**ADDENDUM #02
RFP NUMBER – R22-067 DS
05/12/2022**

NAME OF PROJECT: Transit Campus Expansion Furniture

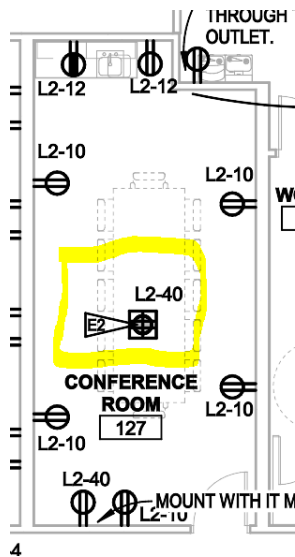
21) In the conference room is power, data, USB or HDMI needed in the middle of the conference table?

- 22) In the conference room is there a floor box below the table?
Yes, see screen capture.

This might be a convenient option to have. However, as noted in Question 14, this may be accomplished with either a simple passthrough hole with a cover, or by a concealed/‘flip-up’ receptacle station. If there is a significant cost difference, then a simple passthrough hole with cover is an acceptable alternative to a flip-up receptacle station. However, a flip-up receptacle station may be the most aesthetically pleasing option; defer to proposer’s best judgment.
